National Science Conservation Centre
Twycross Zoo

Design & Access Statement Addendum_P02

December 2024

HLM
Architects

1.02 Proposal Development
NSCC Concept Entrance View

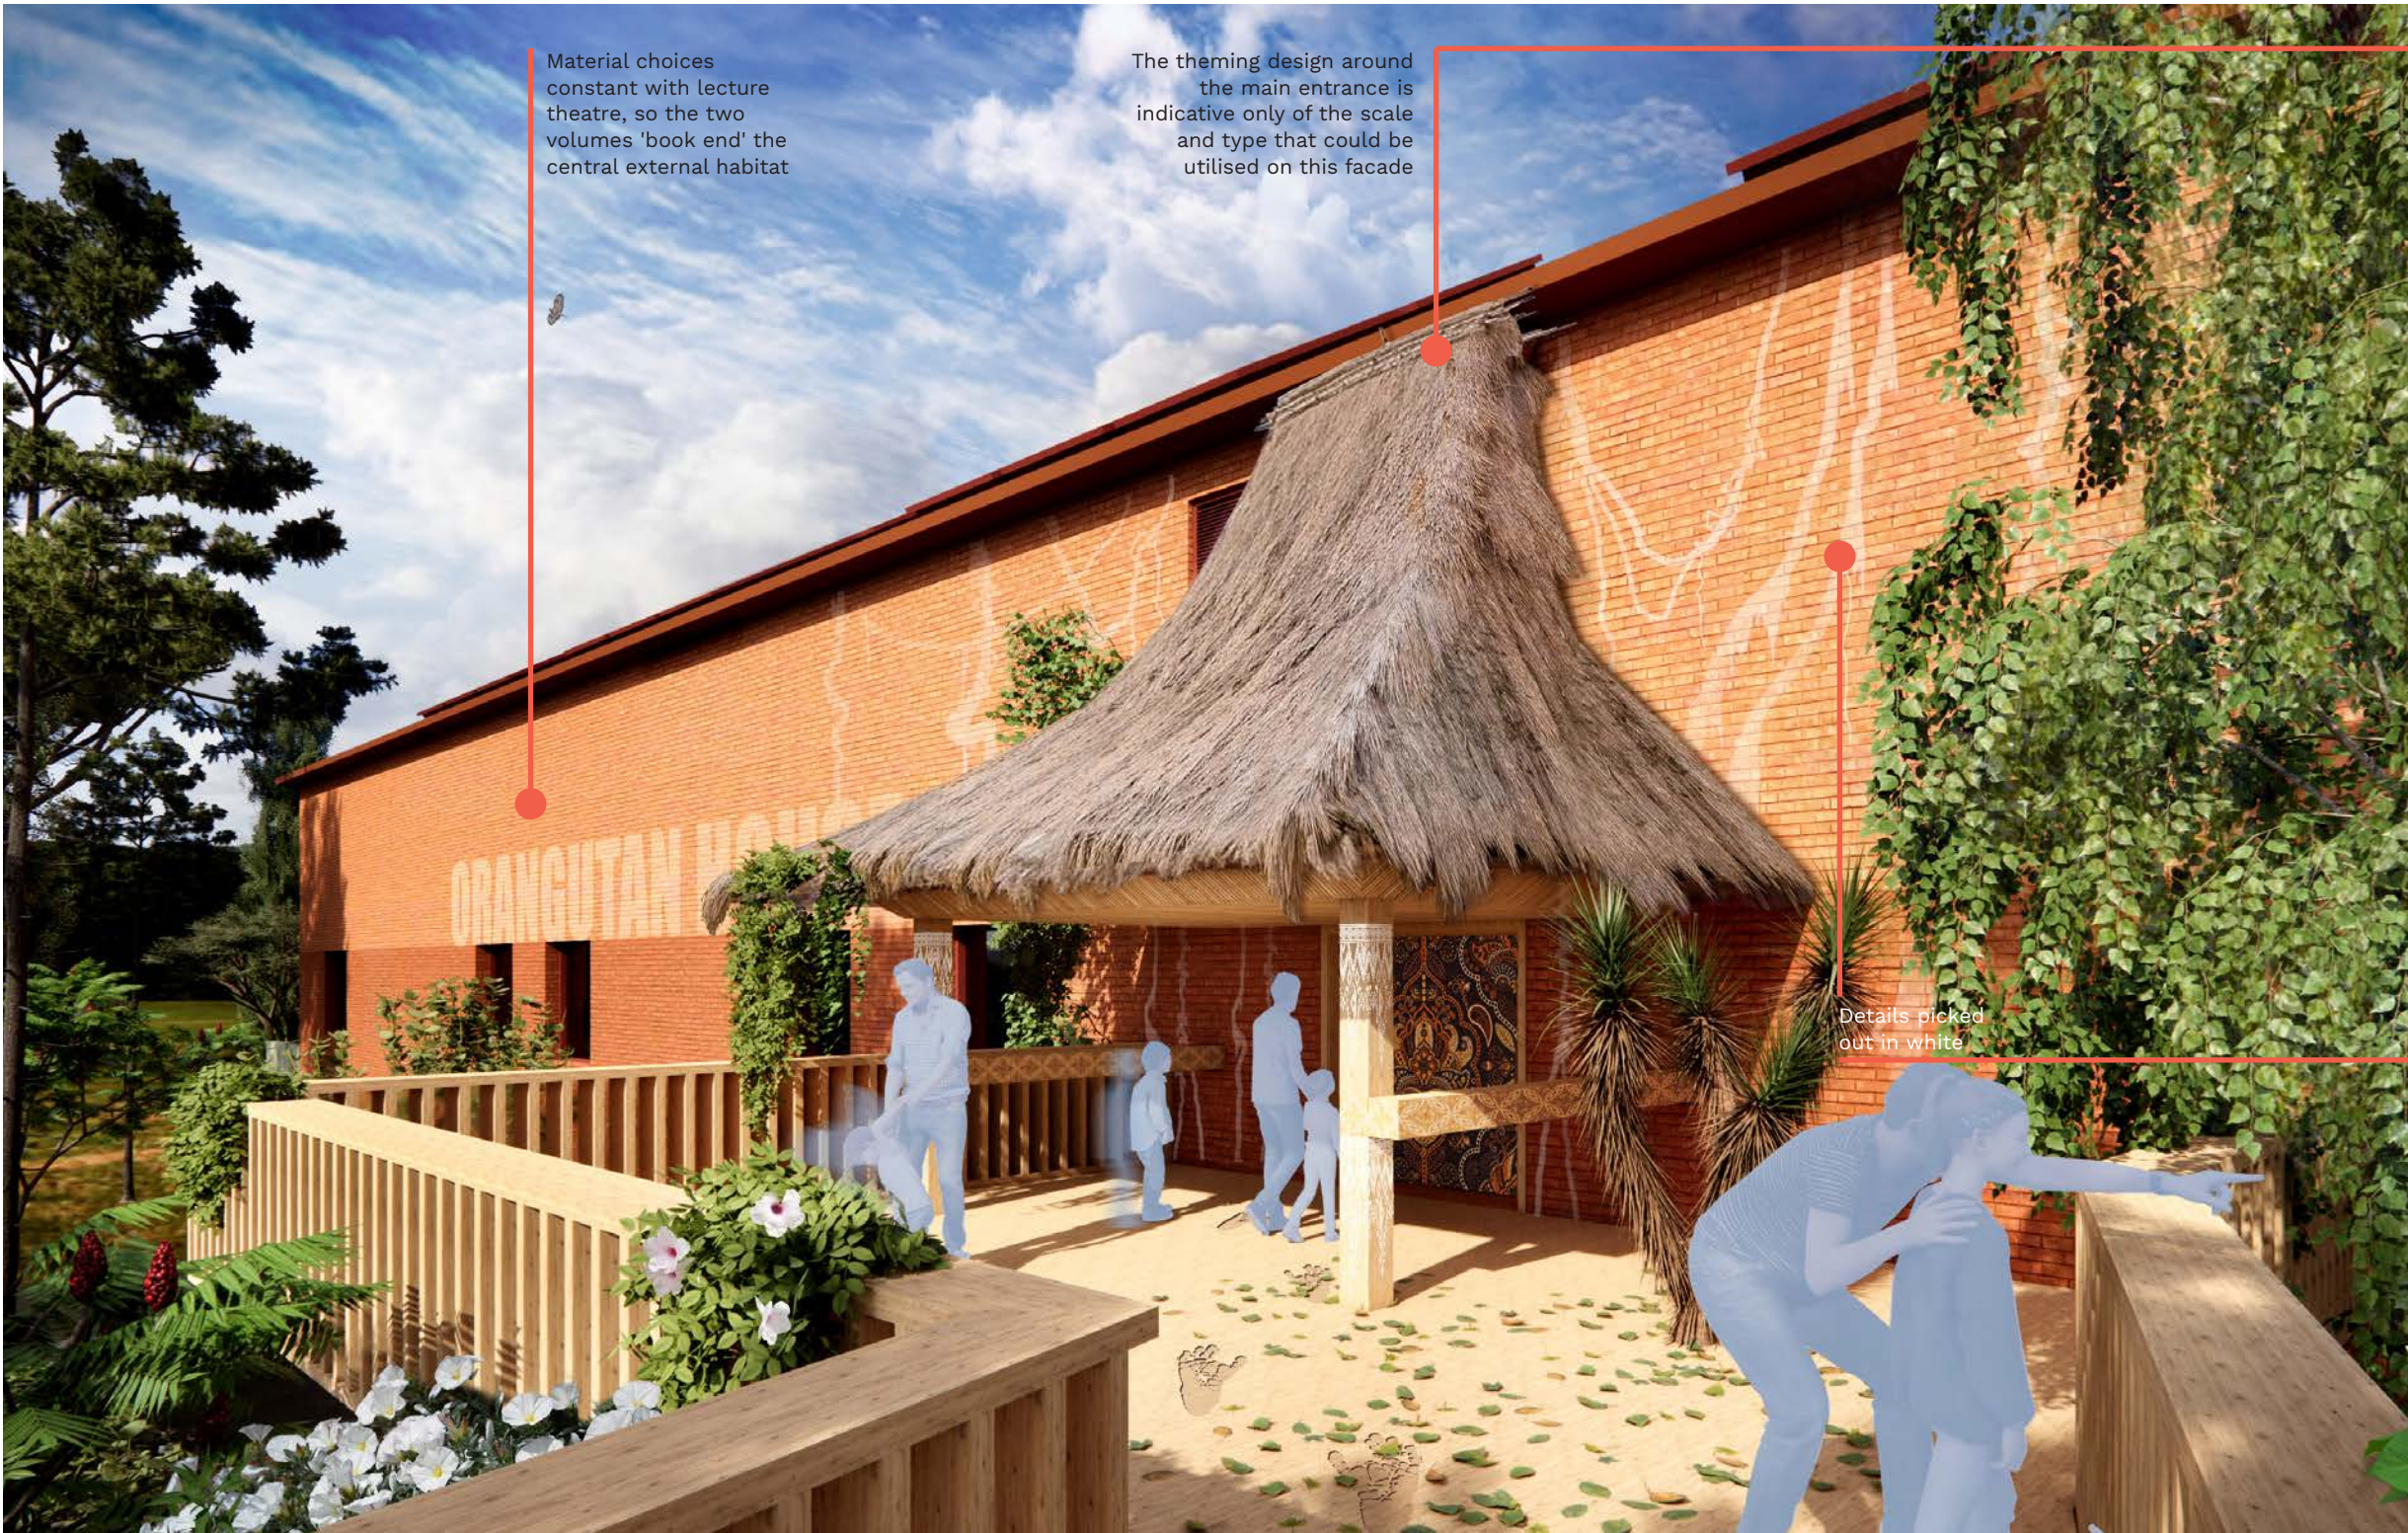
Flemish bond brick with projecting header adding high quality detail to the lecture theatre elevation

Elevation A

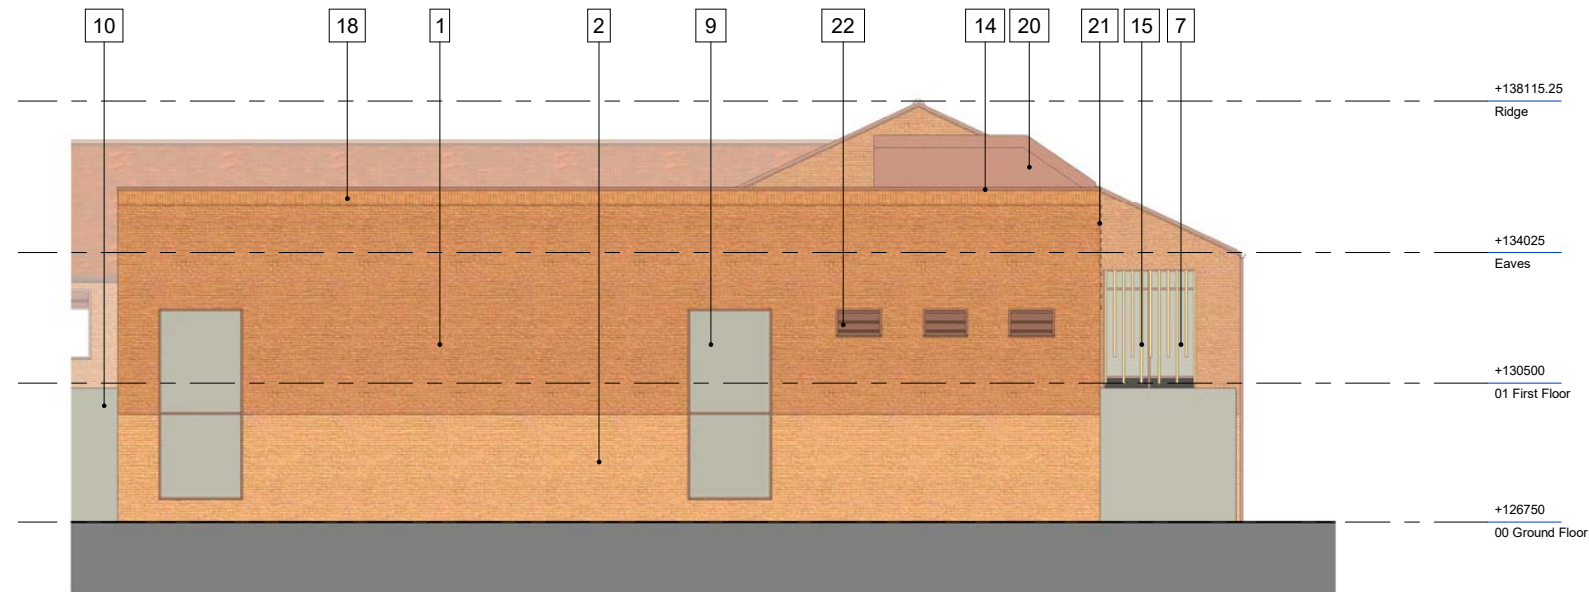
We have looked to address the Theatre Block of the NSCC building and its principal elevation (Elevation A), which, in the Section 73 application, was changed and proposed to be all stretcher brick bonding with two brick colour bandings corresponding to the simplification of the adjacent elevations.

In response to the LPA comments, the following materiality is now proposed to the Lecture Theatre Façade:

- All elevations (4no) - Double soldier coursing to the head of parapets.
- Principal elevation (1no facing car park) – Single Soldier course header to 2no doors and projecting Flemish bond brickwork to upper third.
